SB-10051569-2530

Slack Adjuster Control Arm
GU

PI0767, Slack Adjuster Control Arm

(February 2013)

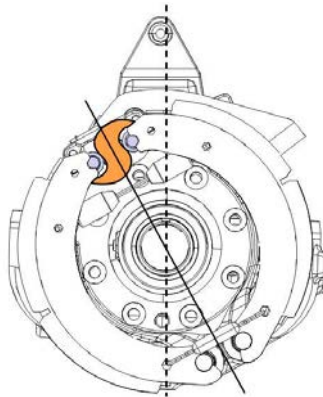
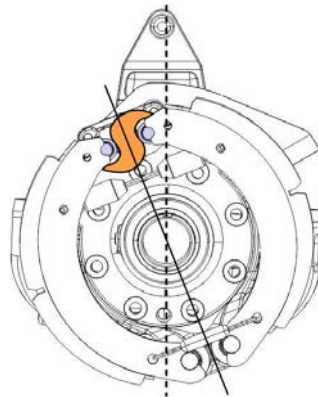
Certain GU model chassis' equipped with Haldex slack adjusters and Ridewell suspension may exhibit a condition which allows the slack adjuster control arm to make contact with the Ridewell suspension walking beam during steep suspension articulation. The articulation interference is possible only in the unloaded condition. A new brake package and slack adjuster are required to prevent this condition.

Old geometry

New geometry

- 9 Remove the spider hardware.
Note: Includes removing the wheel speed sensor and dust shield.
- 10 Remove the complete brake assembly.
- 11 Clean the mating surface of the axle and install the new brake assemblies (all parts and quantities, except seal) with all new spider hardware, and torque to 407 ± 41 Nm (300 ± 30 ft-lb).
Note: The new assemblies reorient the spider assembly rearward to provide sufficient clearance between the Slack adjuster control arm and the suspension walking beams.

W5080036

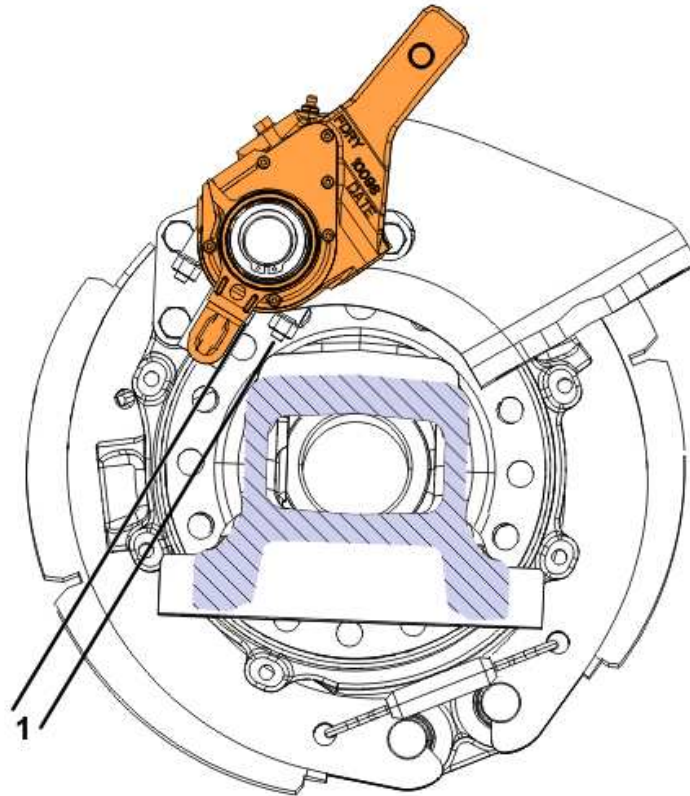
1 10–25 mm (0.39–0.98 in.) to axle housing

Rotate the slack adjuster's control arm bracket as needed to provide the orientation and clearance as illustrated. Tighten the control arm bracket U-bolt nuts to 27–41 Nm (20–30 ft-lb).
